October 14, 2013

RE: Windlectric REA Application – Amherst Island  
Incomplete and Deficient Noise Report

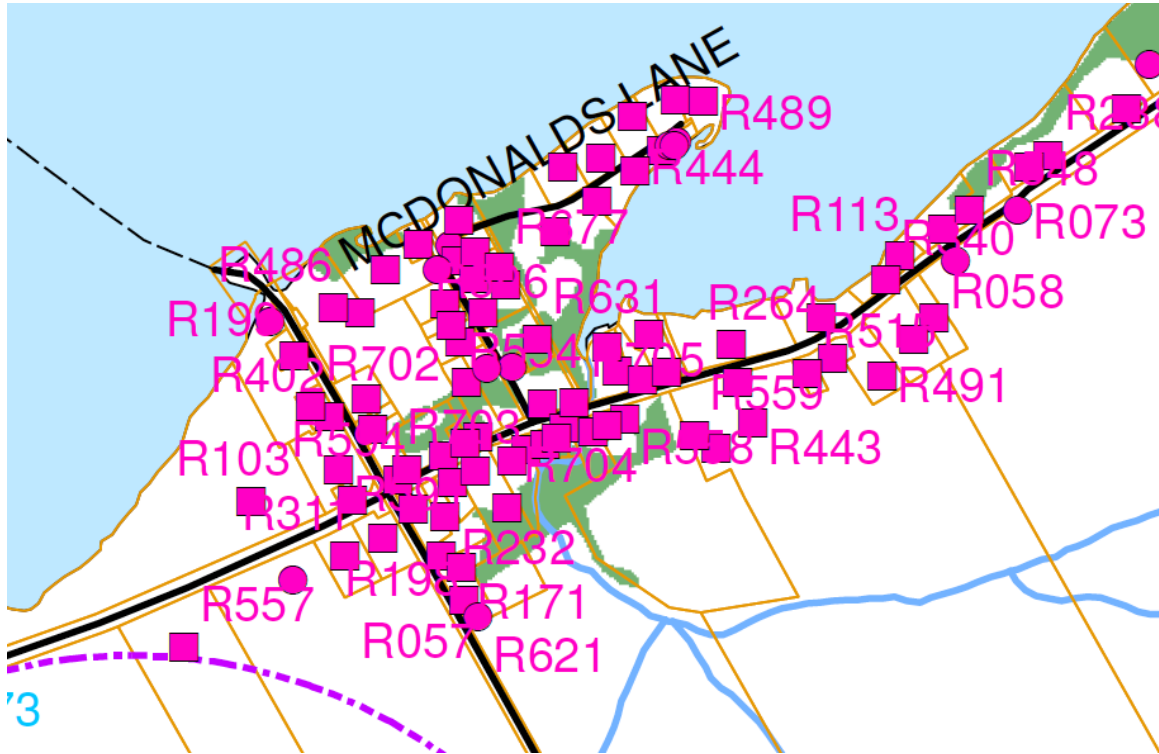
For example, even when significantly magnified (800%) as shown in the extract below and with the help of a Professional Engineer, it is impossible to relate property boundaries and specific locations to receptor numbers on the map provided by Hatch in its report "Windlectric Inc. Noise Assessment Report for Amherst Island Wind Project H340642-0000-07-124-002 Rev 3 November 28, 2012" and embodied in the Amherst Island Wind Energy Project Design and Operations Report prepared by Stantec dated

There is no match between the quantity of receptors and the “R” numbers shown by the receptors. The size of the dots/circles and the R numbers do not match the map scale and consequently it is impossible to make sense of the information. In my best effort to help residents understand the impact on Stella we tried to simply look at a range of R numbers but the Receptor numbers seem to be randomly assigned such that R631 is in close proximity to R264. While the map is already unreadable, using the same colour for the Receptor numbers and the dots/circles exacerbates the problem.

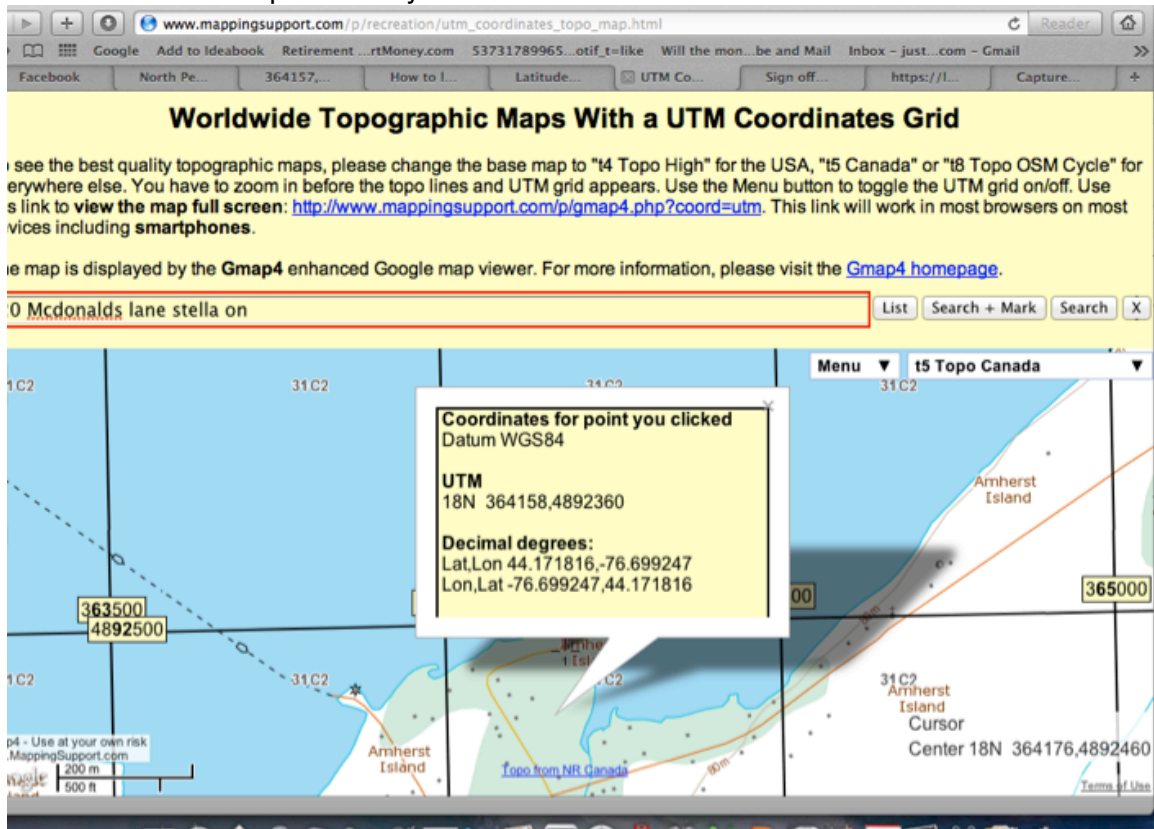
I appreciate that the screen shot below is not an exact match as I was unable to position the cursor to the level of accuracy required and the datum is different but I believe the result demonstrates that it is impossible for the normal mortal to match their property with the information provided by Winlectric/Hatch.

What is needed is a table listing emergency or street address with the noise and shadow flicker information. Be assured we also tried to use MPAC's assessment roll information and realtor files. It simply can't be done!

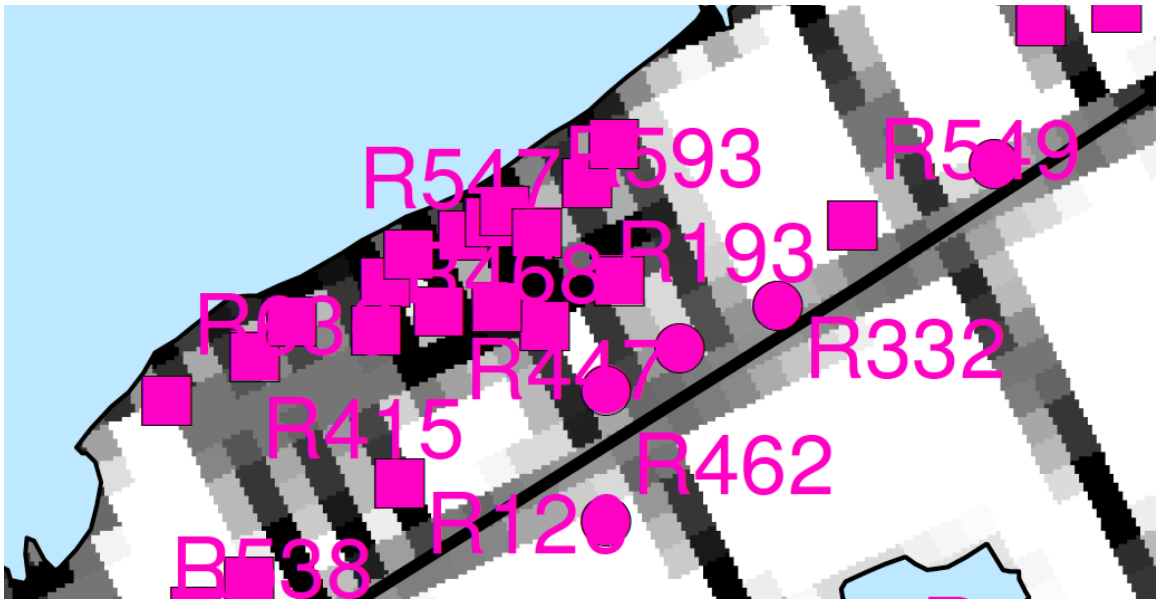
And it's not just Stella Village, other areas of the Island are equally unreadable even at 800% magnification:

In addition to the Receptor numbers being illegible in multiple places, there are Receptor numbers without dots and dots without Receptor numbers.
